Modifications for the Kenwood T-599
Service Notes on T-599A/D

Trio-Kenwood Communication, inc.

Service bulletin no. 7 (2-11-1977)

Reducing 120Hz hum in T-599D

FOIL SIDE OF BOARD

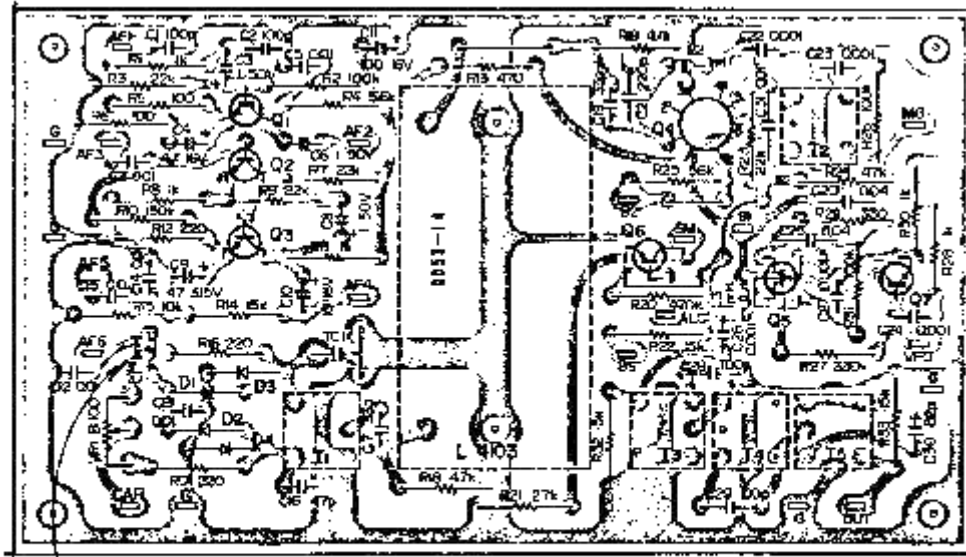
There have been some cases of 120Hz hum in the T-599D. This may be reduced by removing L-1 (1mH) on the generator unit (X52-0009-00) and replacing it with a 47 ohm resistor. Shown below is the generator unit board with this change.
